**Feasibility Study Monitoring Well Installation Plan  
for RVAAP-66 Facility-wide Groundwater**

**Former Ravenna Army Ammunition Plant  
Portage and Trumbull Counties, Ohio**

Appendix A.	Ohio EPA Comments
-------------	-------------------

**Subject: Response to Ohio EPA Comments on the "Draft RVAAP-66 Facility-wide Groundwater, Feasibility Study Monitoring Well Installation Plan" dated September 20, 2022**

Figure 2-5. RVAAP-16 Fuze and Booster Quarry Feasibility Study Well Locations

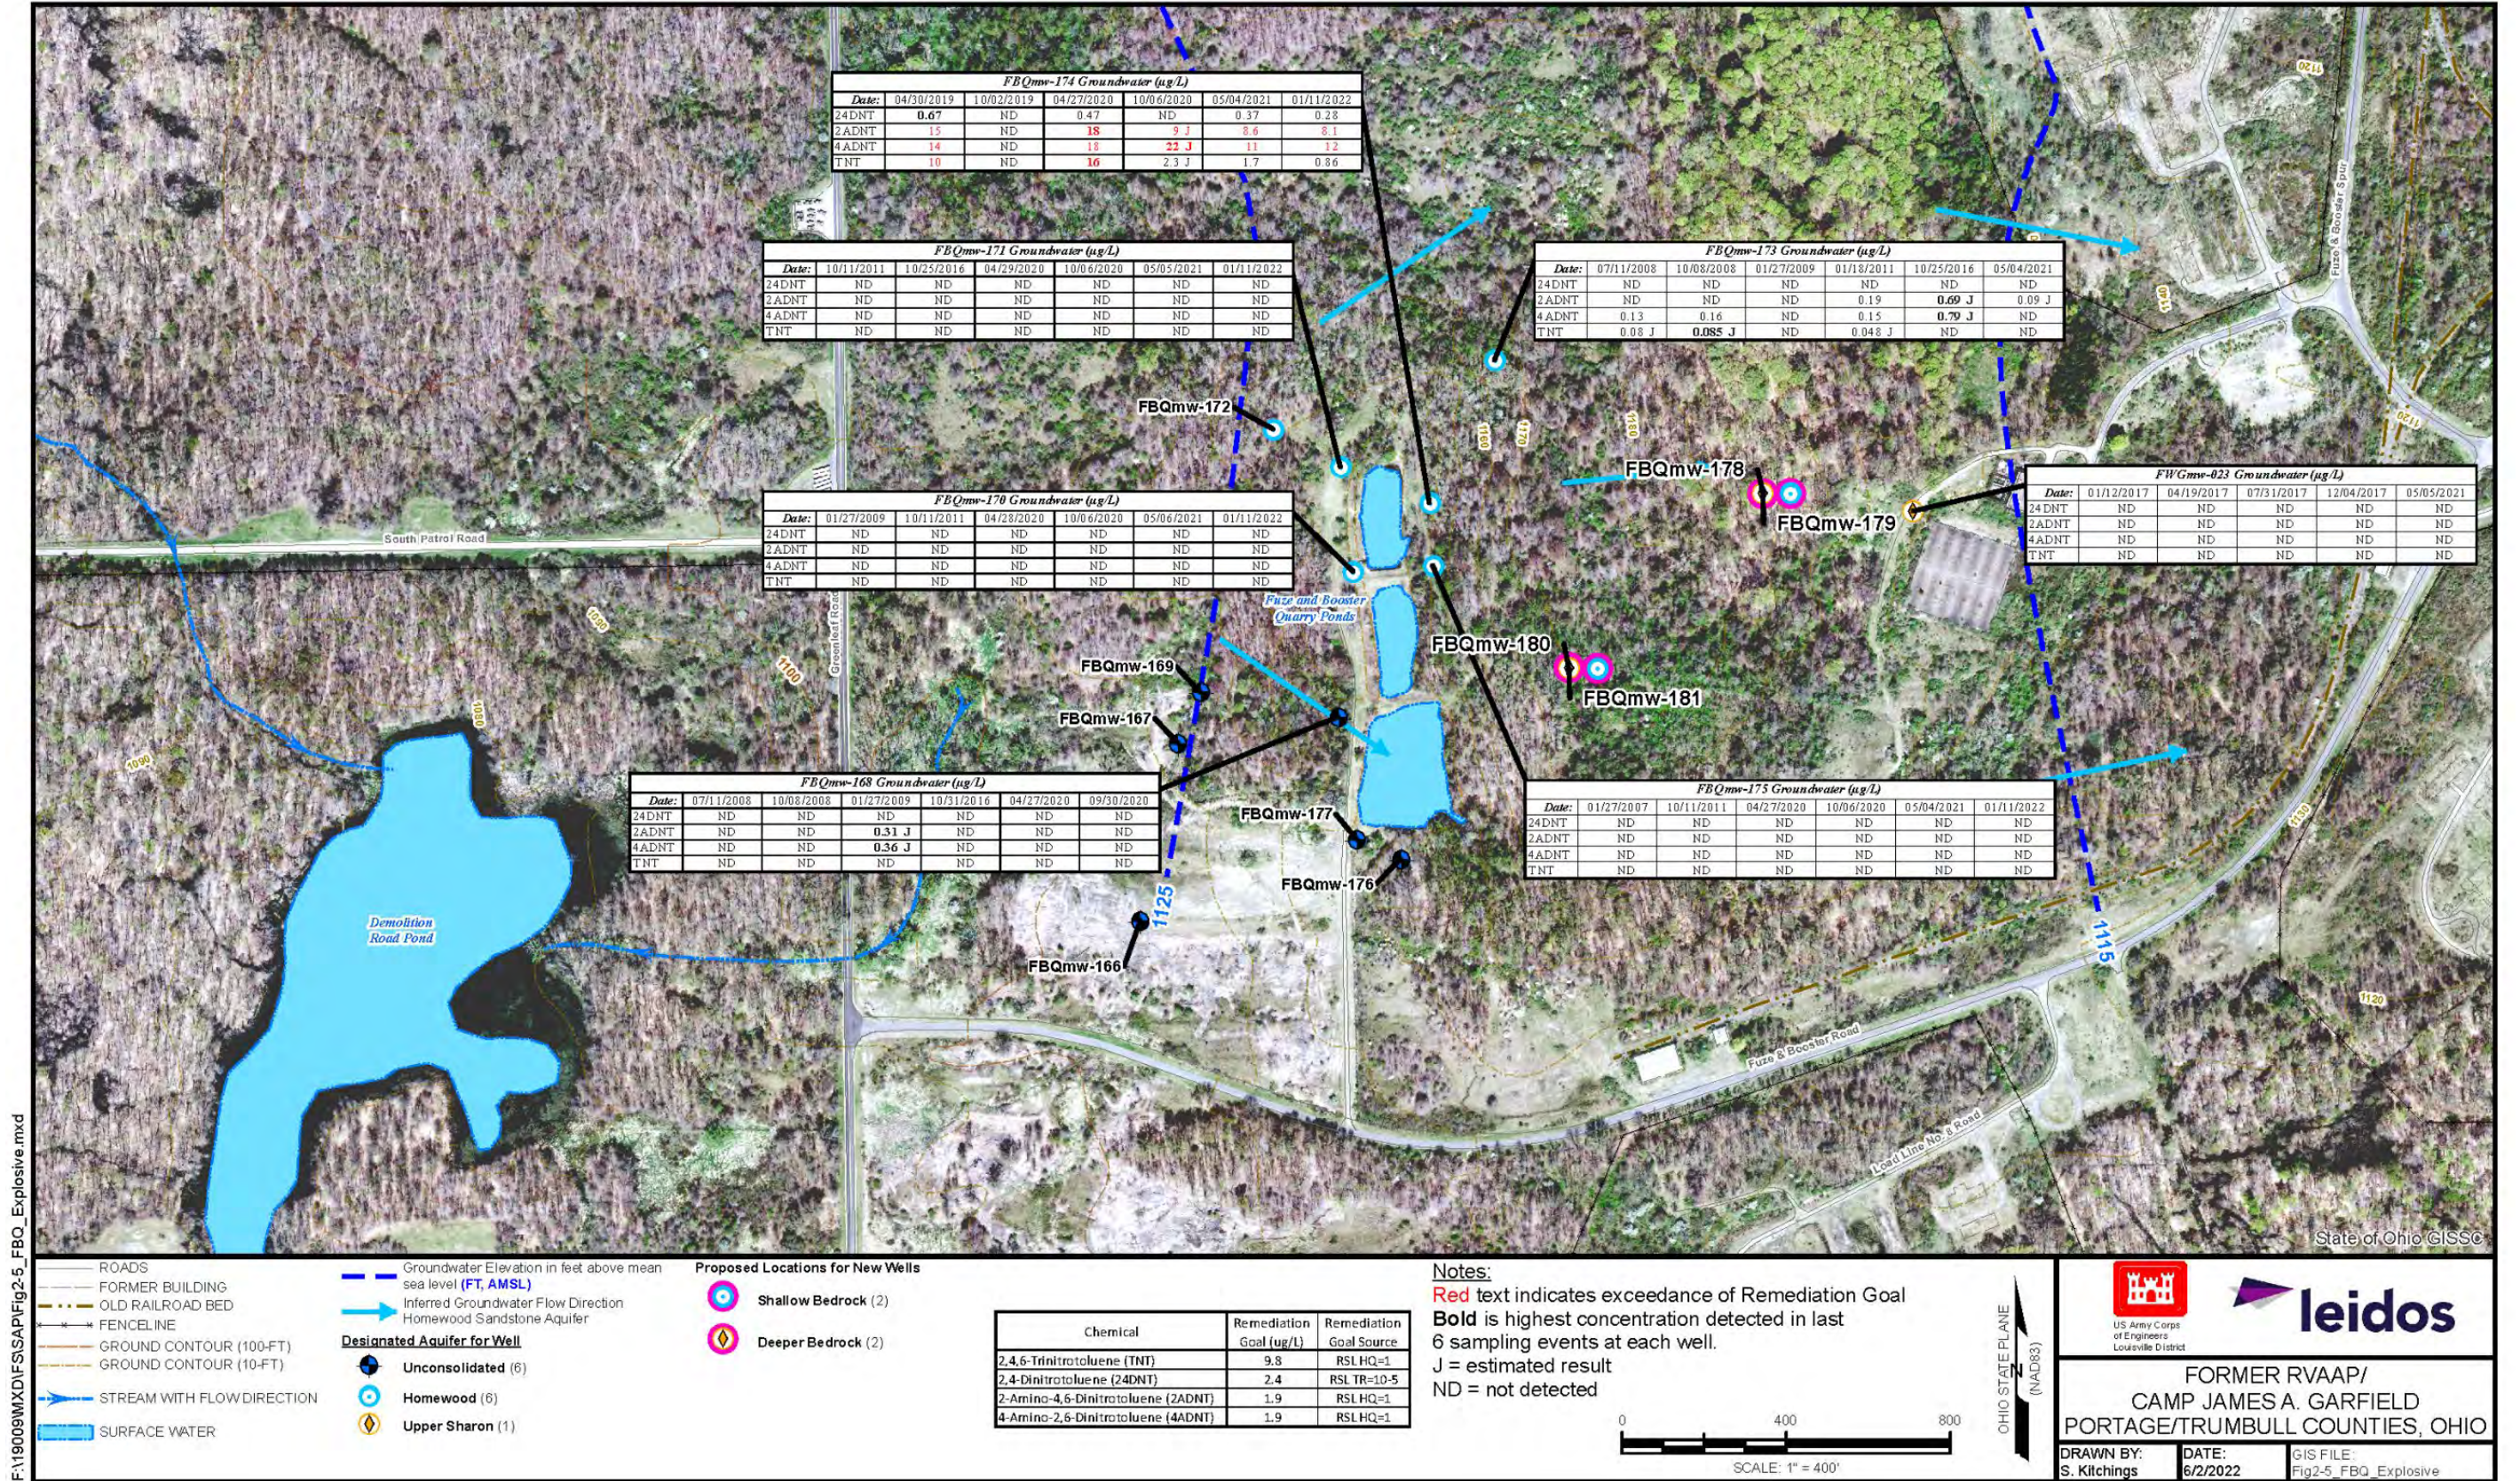
Ohio EPA concurs with the proposed installation of four monitoring wells (two well pairs) to be installed in order to supplement the FS, specifically around FBQmw-174. Further discussion on the proposed locations as denoted on Figure 2-5 of the Draft FS Additional Well Install Plan 2022 is requested, as the current proposed location for FBQmw-178/179 being 900 feet east of FBQmw-174 may be too far to provide good delineation and modelling data. The preferred location may be further west closer to FBQmw-174 (i.e., within 200-300 feet), however that may be at the crest of the hill, so further discussion is warranted to logistically place this boring. Upon closer inspection of the potentiometric map of the area and bedrock mapping, the proposed FBQmw-180/181 to the east may be better located to the west of FBQmw-174 and FBQmw-170/171, since bedrock highs on Camp James A. Garfield (CJAG) typically exhibit radial flow patterns (that may not be apparent at the FBQ area since wells are not located far enough west to show ground water flow completely in that direction). The inferred/presumed eastern ground water flow may not be entirely correct in this area. Additionally, Homewood wells in the FBQ have been installed at depths ranging from 30-50 feet based on topographic surfaces, rather than the proposed 75-90 feet bgs (while this depth may be appropriate east of the FBQ area where the topography demonstrates higher elevations. Please clarify the proposed Upper Sharon deeper bedrock well approximate depths of 140 to 155 feet bgs, as the eastern FWGmw-023 well in the Upper Sharon is installed to a depth of 215 feet bgs.

Ohio EPA concurs with the proposed installation of four monitoring wells (two well pairs) to be installed in order to supplement the FS, specifically around FBQmw-174. Further discussion on the proposed locations as denoted on Figure 2-5 of the Draft FS Additional Well Install Plan 2022 is requested, as the current proposed location for FBQmw-178/179 being 900 feet east of FBQmw-174 may be too far to provide good delineation and modelling data. The preferred location may be further west closer to FBQmw-174 (i.e., within 200-300 feet), however that may be at the crest of the hill, so further discussion is warranted to logistically place this boring. Upon closer inspection of the potentiometric map of the area and bedrock mapping, the proposed FBQmw-180/181 to the east may be better located to the west of FBQmw-174 and FBQmw-170/171, since bedrock highs on Camp James A. Garfield (CJAG) typically exhibit radial flow patterns (that may not be apparent at the FBQ area since wells are not located far enough west to show ground water flow completely in that direction). The inferred/presumed eastern ground water flow may not be entirely correct in this area. Additionally, Homewood wells in the FBQ have been installed at depths ranging from 30-50 feet based on topographic surfaces, rather than the proposed 75-90 feet bgs (while this depth may be appropriate east of the FBQ area where the topography demonstrates higher elevations. Please clarify the proposed Upper Sharon deeper bedrock well approximate

The well pair FBQmw-178 and 179 were located to the east of FBQmw-174 to address the Ohio EPA comment noted in the RI that horizontal and vertical delineation to the east is warranted. As noted, the ideal location would have been 200-300 feet east of mw-174, however, this is the crest of the hill as observed in Ohio EPA comment above and likely potential exists for a localized radial flow pattern. The well pair FBQmw-180 and 181 was located to further address delineation to the southeast. The contamination at mw-174 is otherwise bound by the ponds to the west and wells to the north and south and groundwater elevation measured routinely in adjacent wells demonstrates groundwater flows toward FBQmw-173 and FBQmw-175, away from mw-174. Only flow gradients to the east and southeast are unknown.
